RANCHO MURIETA COMMUNITY SERVICES DISTRICT

IMPROVEMENTS COMMITTEE

Special Meeting
September 18, 2024 at 8:00 a.m.

Subject: Submittal Response

ASC Project # B22360	Date 07.20.2023
Drawn By N. ROTAS	Sheet 7
Checked By T. PINION	E6.0
Scale NONE

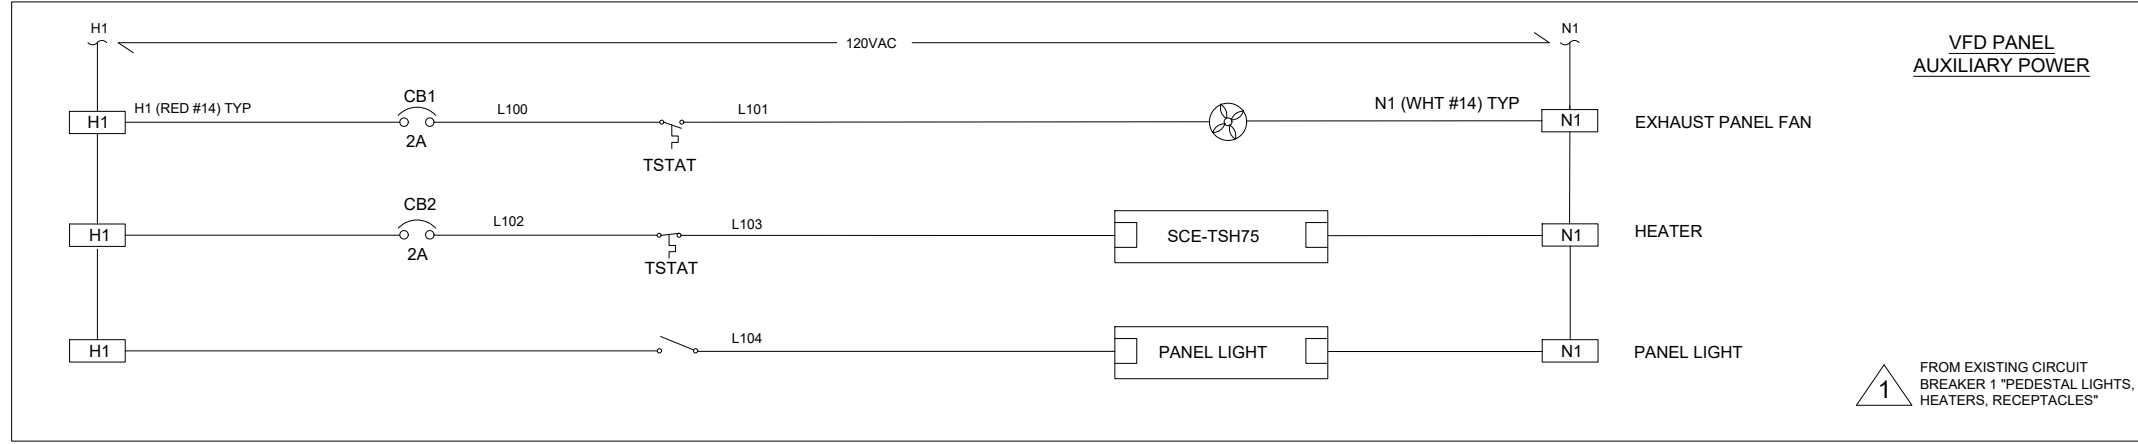
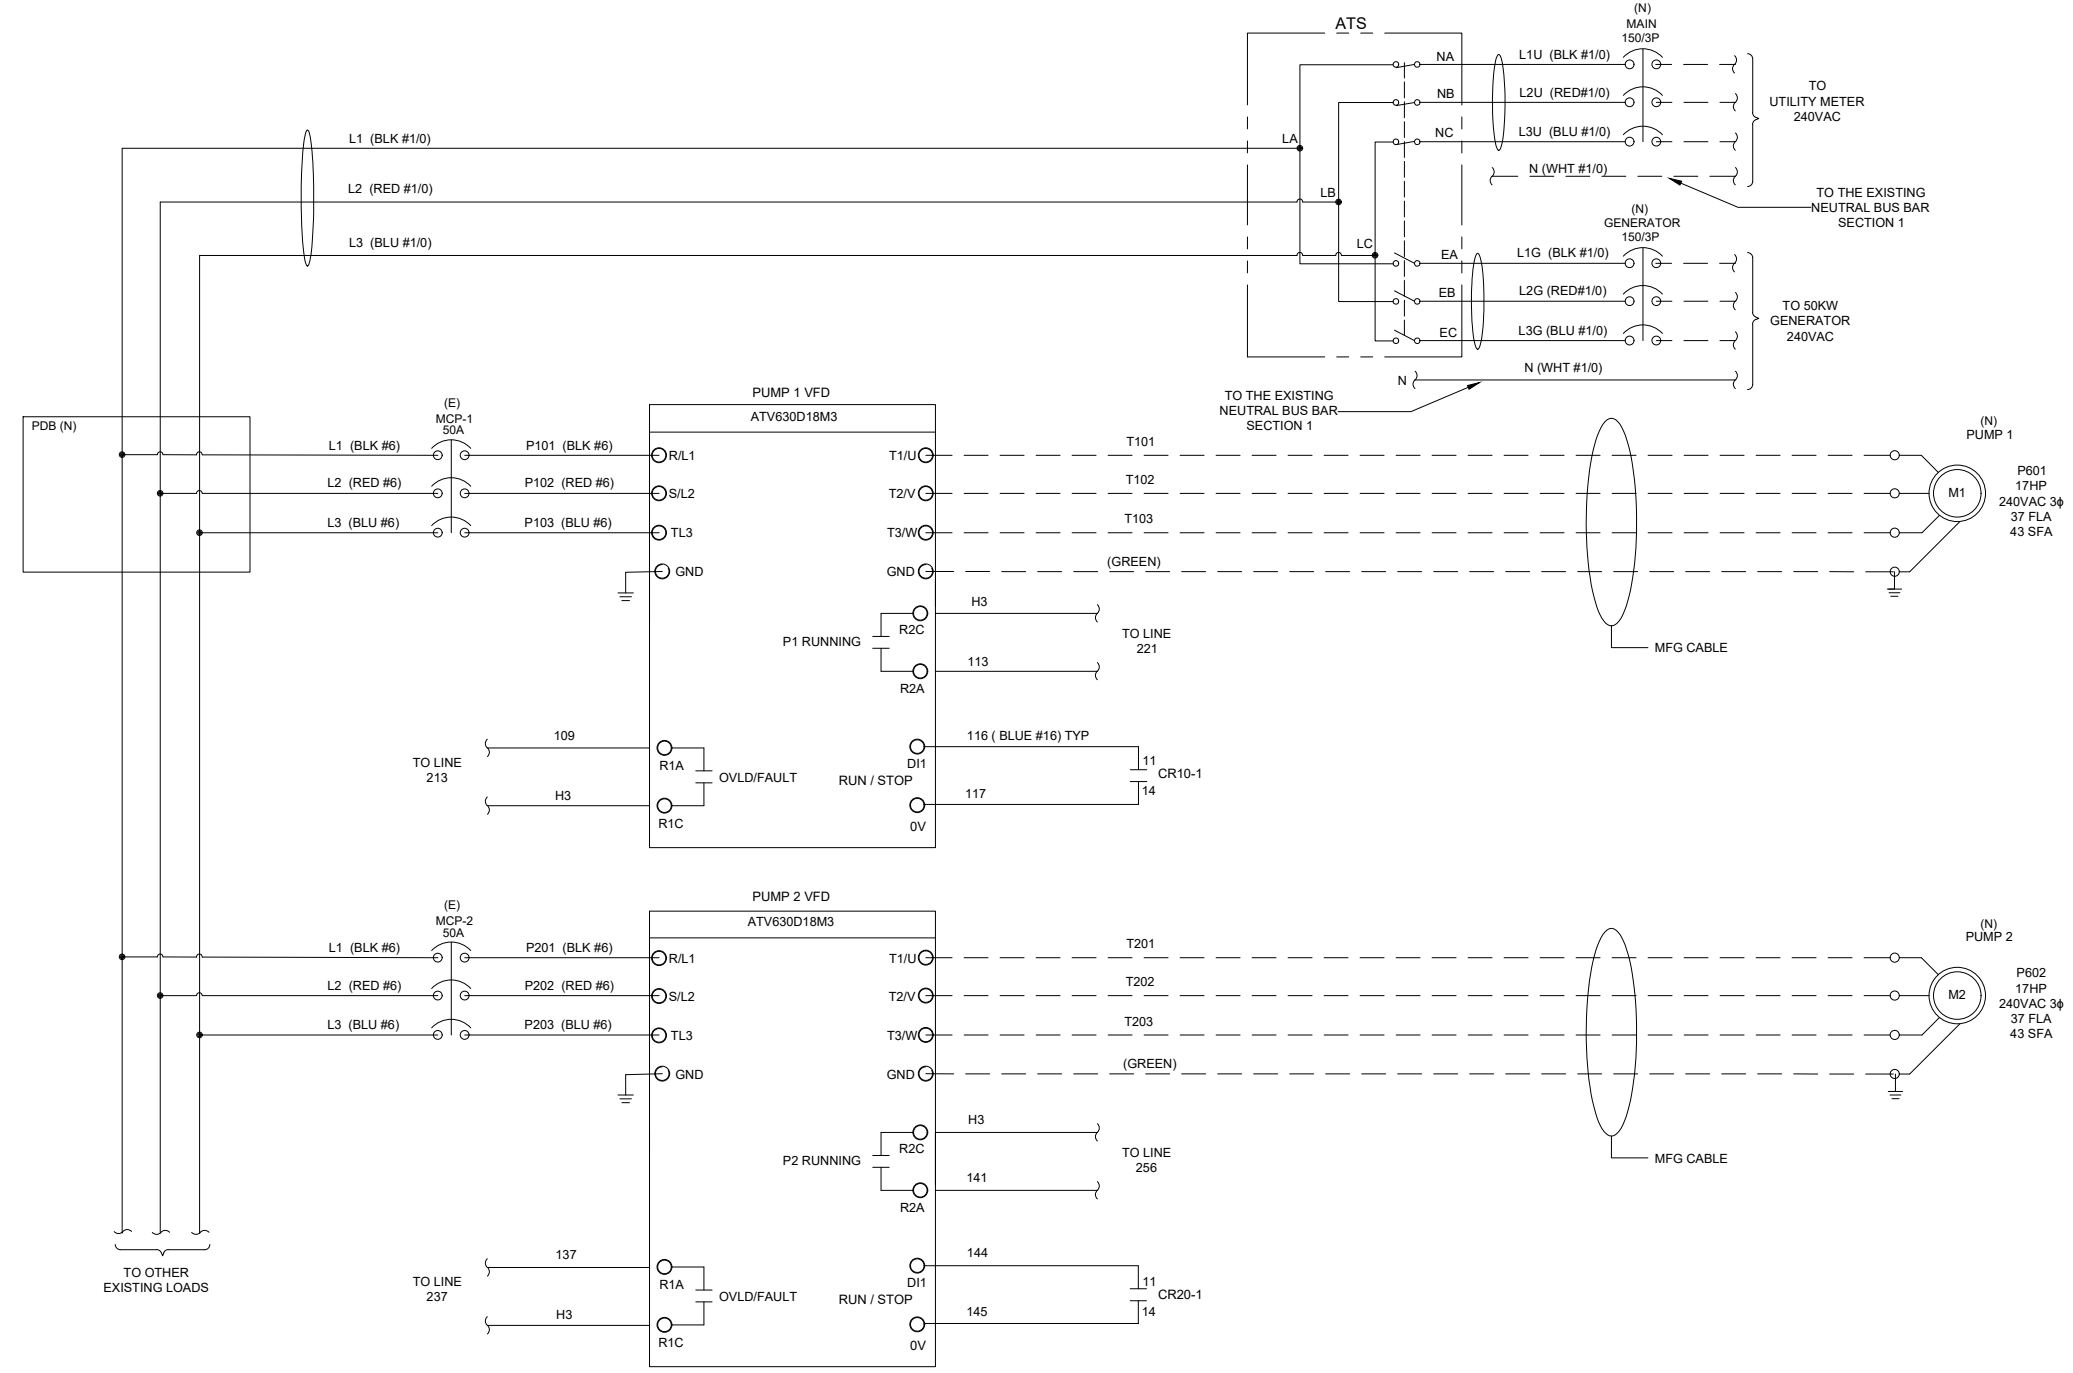
5). E6.0 On the vfds R1 is default as the fault relay, and R2 should be used for the pump running relay. That way it falls in line with our other vfd sites. Also, we would like to move the setting file for the vfds for our records.

Drawing fixed. A VFD settings table will be provided by email after the field installation.

ASC Project # B22360	Date 07.20.2023
Drawn By N. ROTAS	Sheet 8
Checked By T. PINION	E7.0
Scale NONE

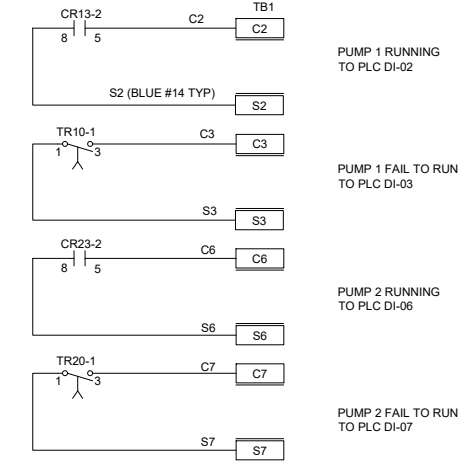
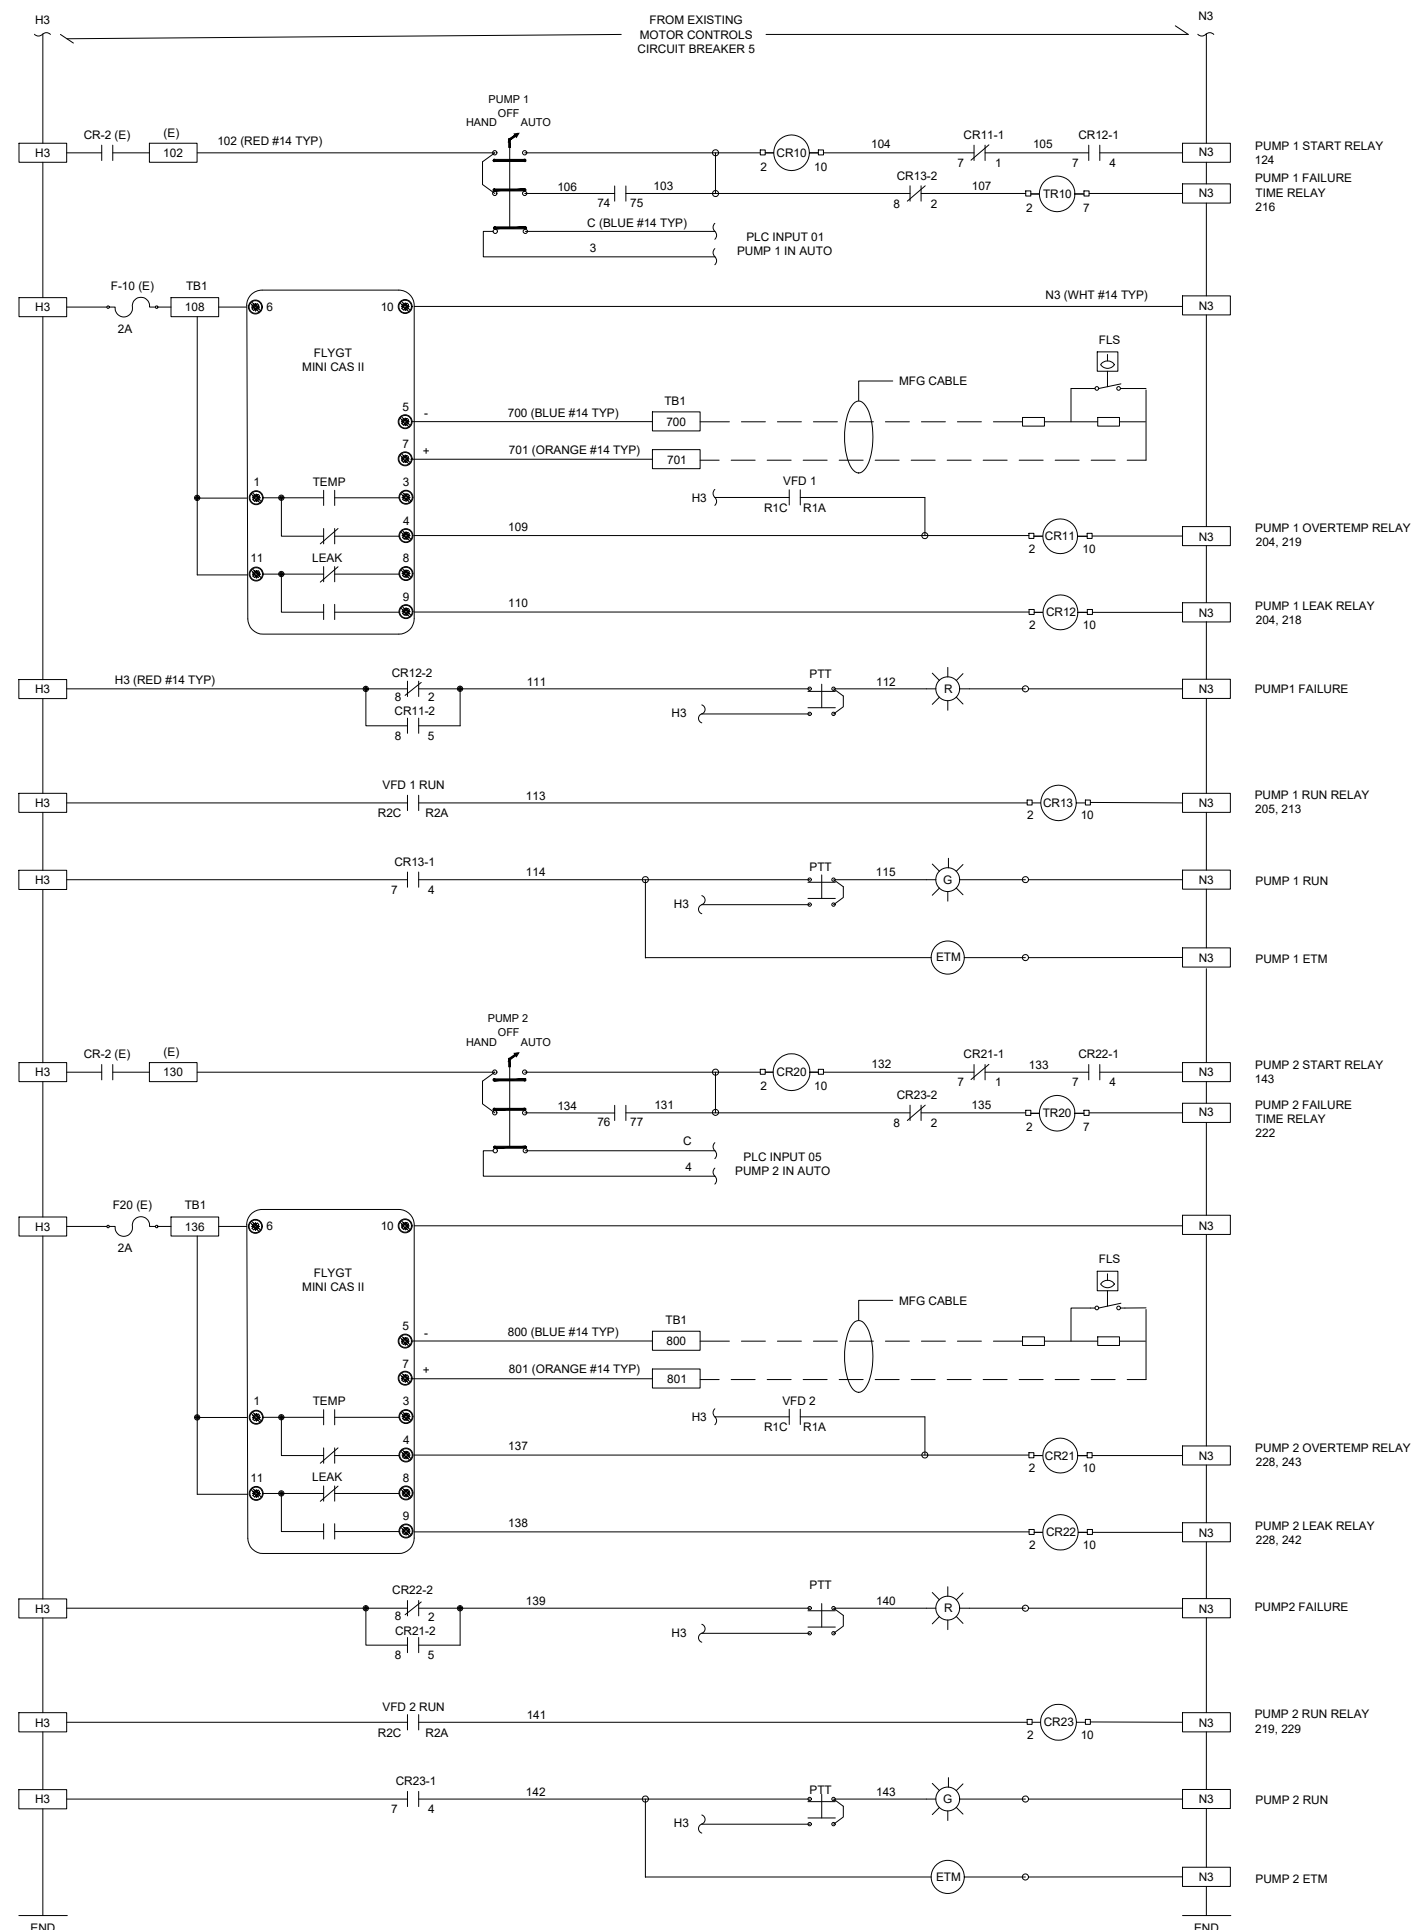
6). E7.0 Looks like most of it was corrected. Also noticed that you still have black control wire in this. Refer to the tesco wire color chart. Most all 120 circuits are to be red with the exception of externally powered which is to be yellow.

Drawing fixed.

ASC Project # B22360	Date 07.20.2023
Drawn By N. ROTAS	Sheet 11
Checked By T. PINION	E10.0
Scale NONE

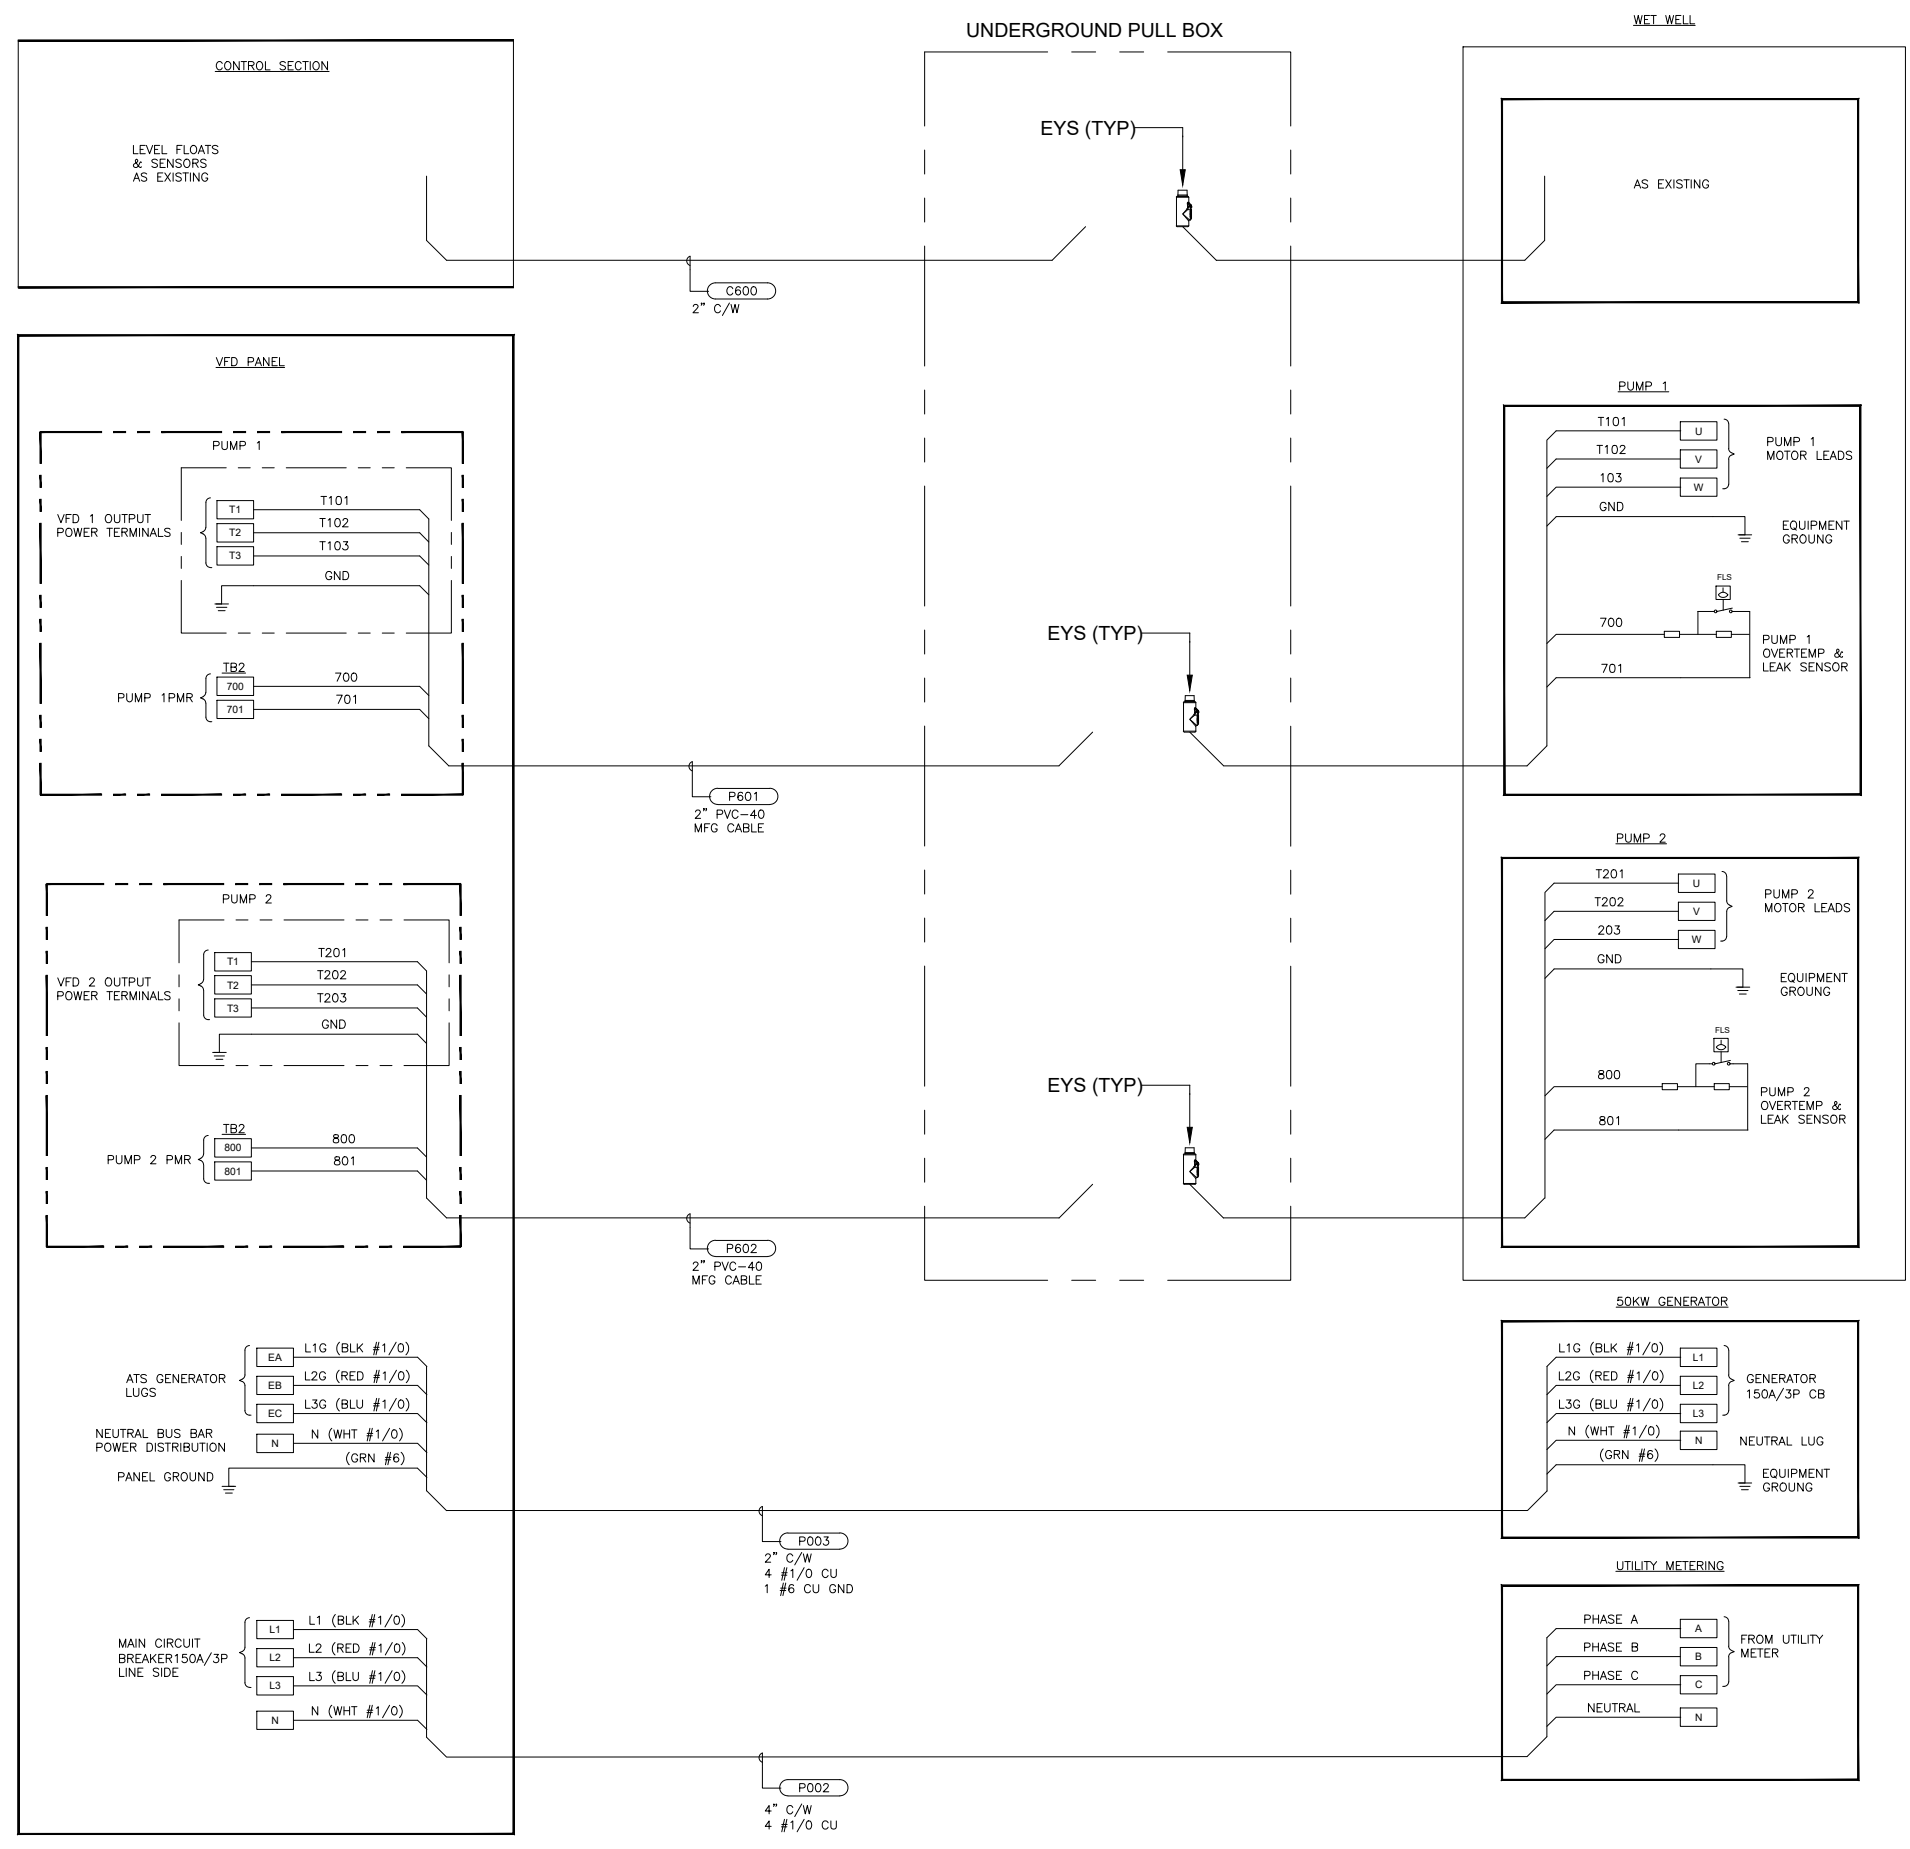
E10.0 i) Interconnections Drawing does not show the underground pull-box which can also denote the placement of the eyes.

ii) In the pull box there are to be no wire terminations, Manufacturer cables are to go continuously from the wet well to their termination point into the panel.

iii) EYS fill. Do not fill the eyes fittings. The district electrician will complete this the day of start-up.

iv) C600 is showing that it goes from vfd panel to wet well. On page E2.0 it shows that c600 goes from wet well to the pull box then to the control section of the panel which is correct. Please change Page E10.0

Drawing fixed.

The pumps have a 50ft cable. This cable is going to the VFD. There is no termination in the pull box.

This is a field procedure.

Drawing fixed.
